REQUEST FOR INFORMATION **DATE:** July 26, 2017 **NO.:** RFI-598

Project Name: 15051-Webster University Interdisciplinary Science Building Project No.: 15051

Subject: Sign Lights

E0001

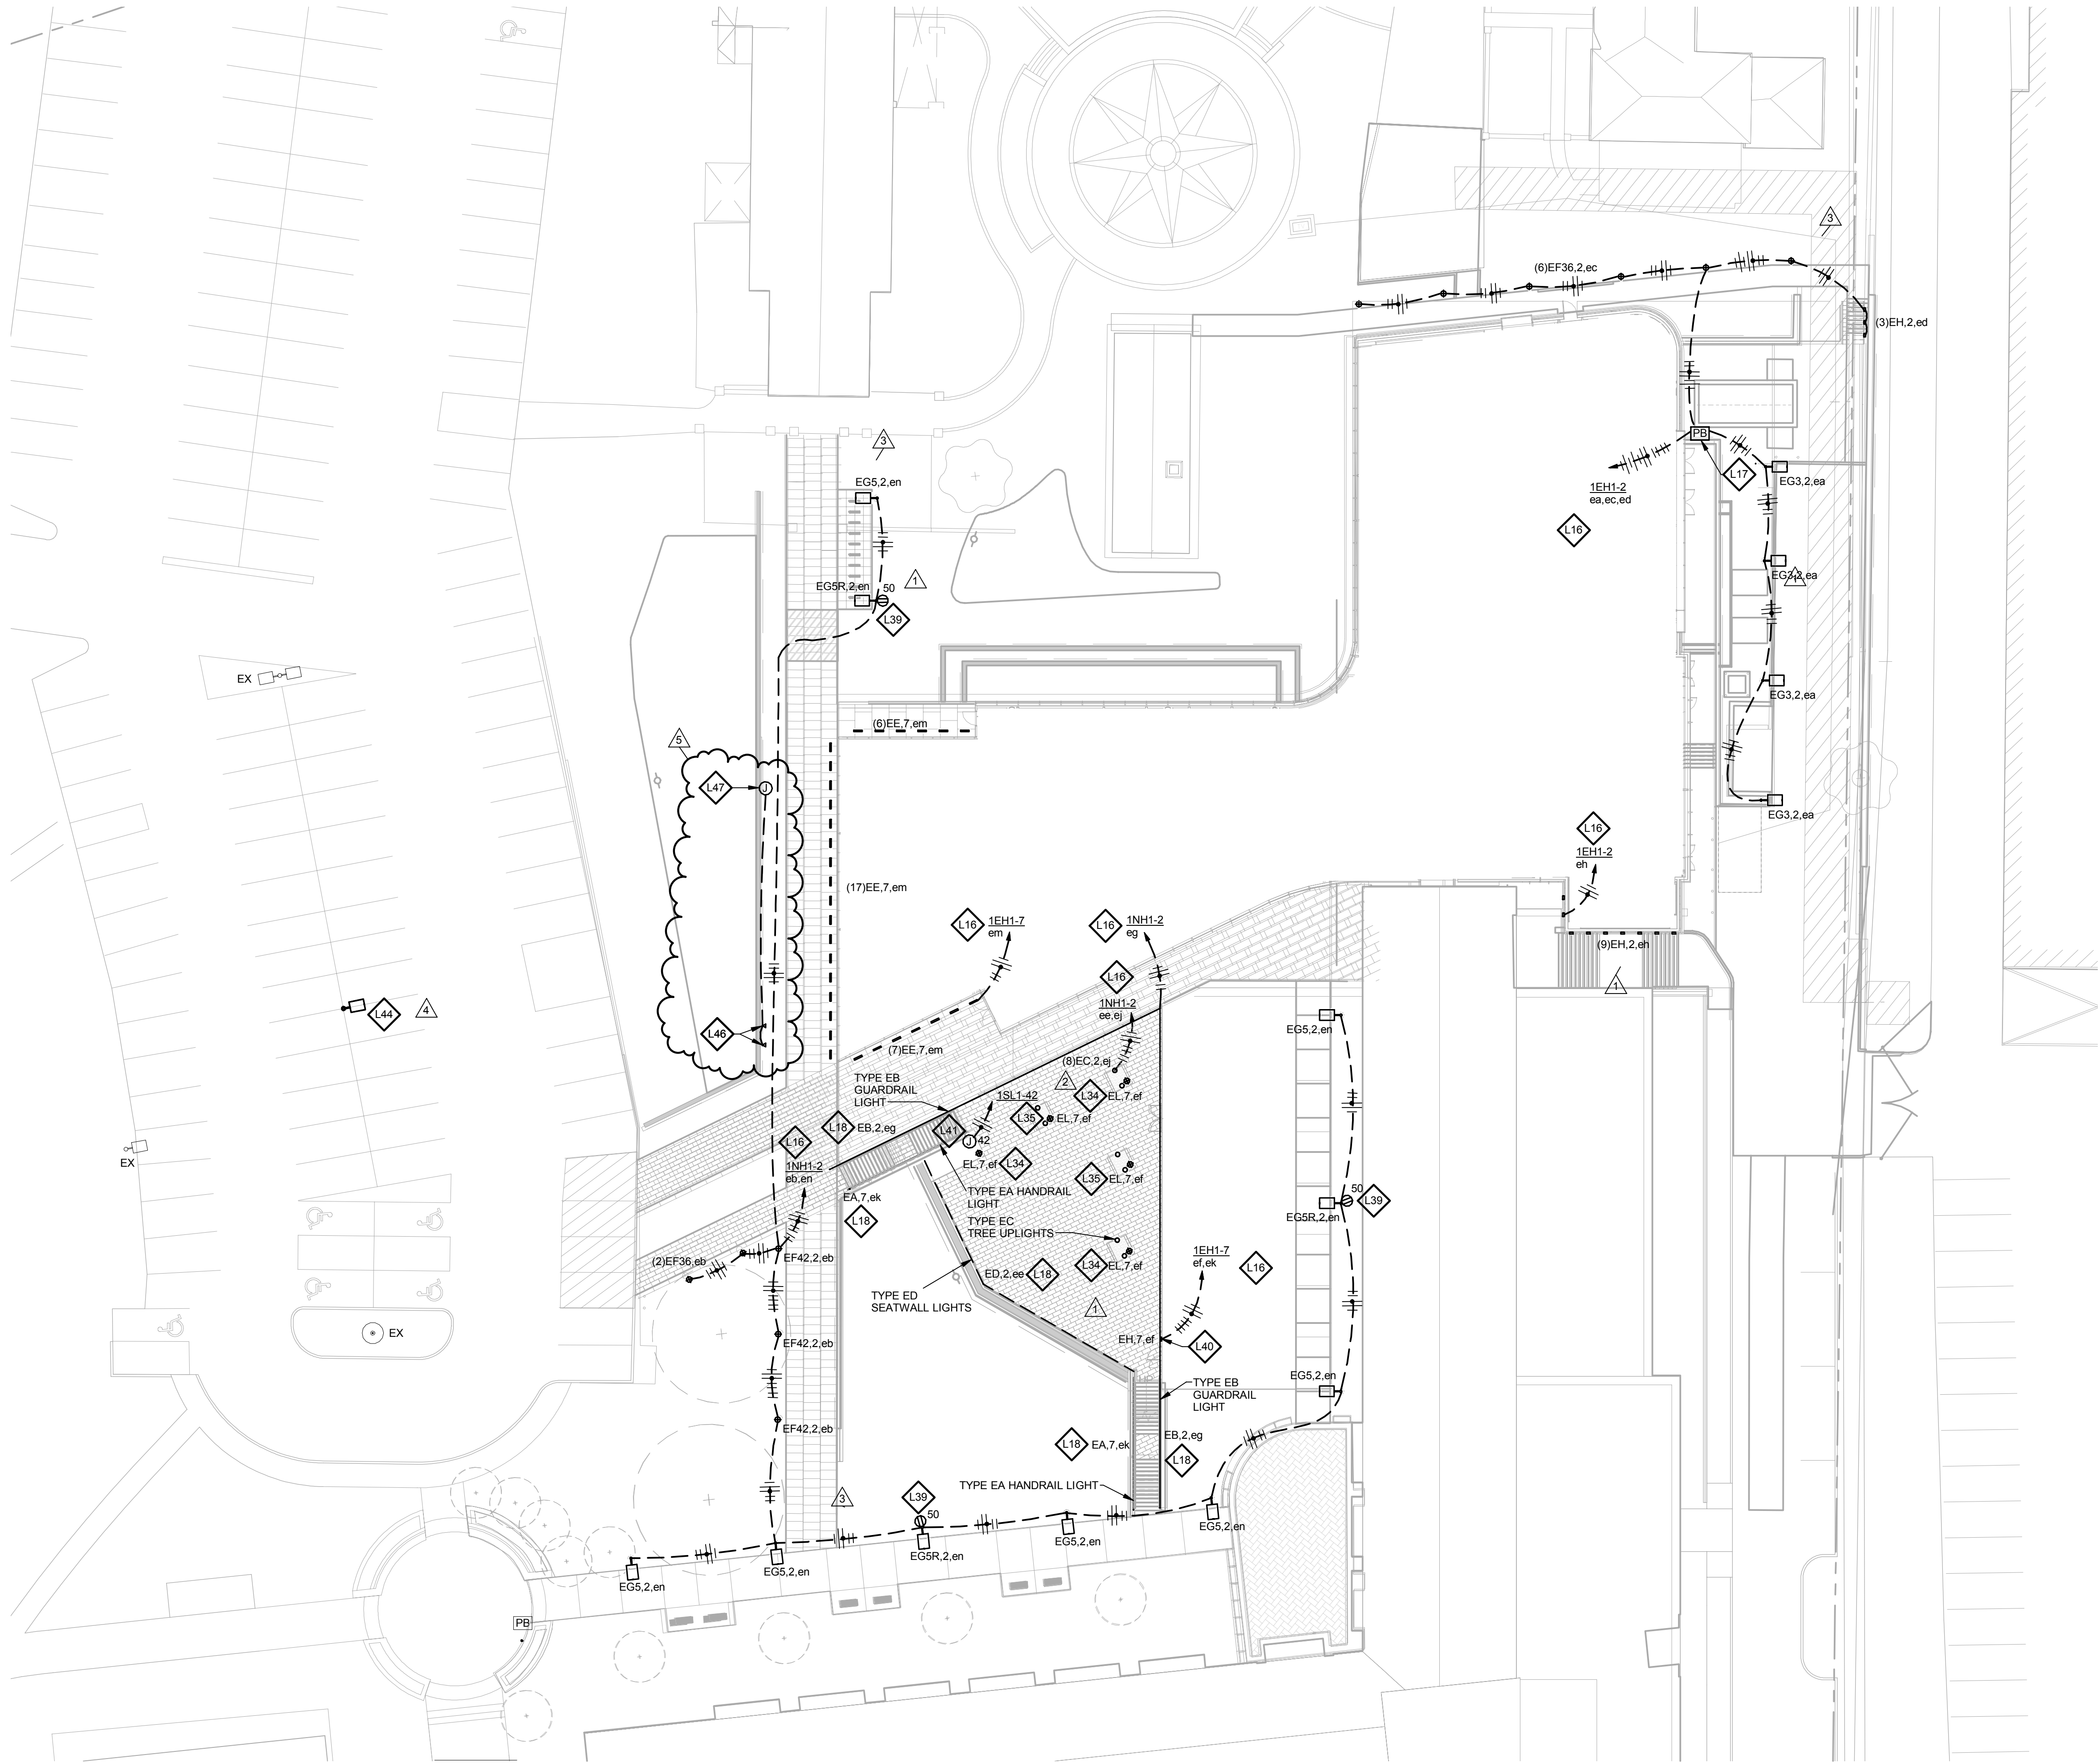
See attached correspondence. Please issue revised drawings as discussed.

We still need to issue an ESI on the "BROWNING HALL" sign lights. You were going to let me know where you can get power from (either our site lighting power or existing parking lot power).

Ideally we could just feed these two new stake mounted lights from the 1NH1-2 circuit that runs by there, but depending on where you routed that circuit, it may not be available.

See attached. The little red dots represent the two low voltage stake mounted lights. there will be a remote power supply (red square) which will have to go in a box (either a box we add, or the same box you will use for the parking lot light).

See attached drawing, Sheet E0001 for sign lighting intent. Submit an itemized quotation for the changes for approval prior to proceeding on the Work.

- L46 PROVIDE TWO (2) BK LIGHTING NS-LED-e65-NSP-A5-BLP-13-11-360SL-POWERPIPE FIXTURES WITH REMOTE TRANSFORMER TO ILLUMINATE BROWNING HALL SIGNAGE. LOCATE APPROXIMATELY 5' O.C., CENTERED ON SIGNAGE, AND 6" FROM RETAINING WALL.

- L47 LOCATE BK LIGHTING TR-60-277 REMOTE TRANSFORMER WITHIN OUTDOOR JUCTION BOX TO SERVE SIGN LIGHTS. CONNECT TO 277V CIRCUIT SERVING OUTDOOR LIGHTING.
